**U.S. Environmental Protection Agency
Region 2**

RESPONSE TO PUBLIC COMMENTS

OUTER CONTINENTAL SHELF AIR PERMIT

**Atlantic Shores Offshore Wind Project 1, LLC
Atlantic Shores Project 1 and Project 2**

Figure 1

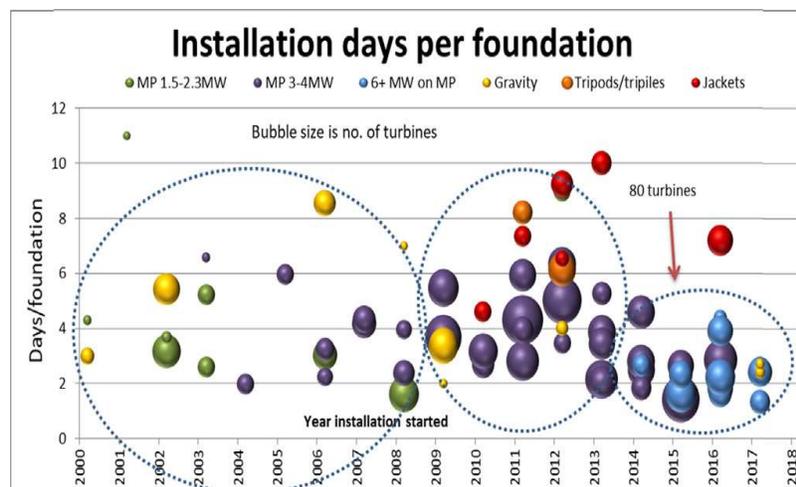
The Epsilon Associates estimate of 2.6 days for foundation installation is supported by real world experience with installation times as shown below.

Figure 2-2: Visibility Metrics levels at Brigantine Wilderness Area

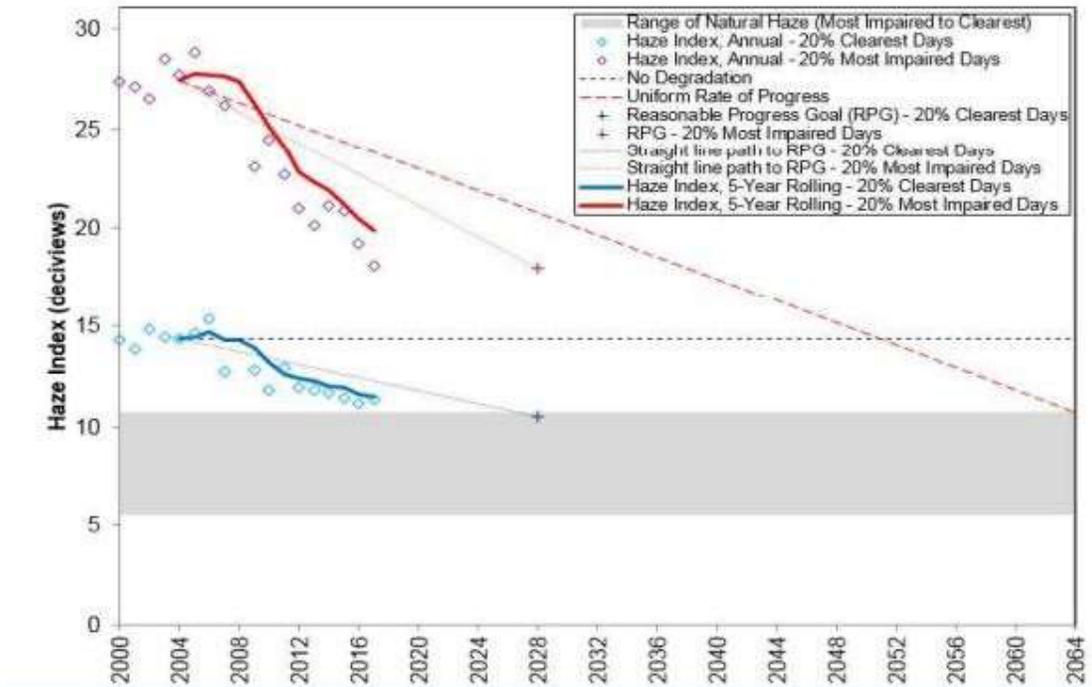
- s) Figure 2-2 of the New Jersey Regional Haze SIP shows that the projected 2028 visibility at the Brigantine Wilderness Area is well below the URP level. Additionally, the figure indicates that the observed 2016 visibility at Brigantine is approximately 6 deciviews below the URP glide path. The average observed visibility from 2018-2022 (see figure below) shows more than 6 deciviews below the URP glide path. Therefore, any potential increases in visibility degradation at Brigantine due to the project would not endanger Brigantine's visibility remaining below the URP glide path and meeting the regional haze rule goals.
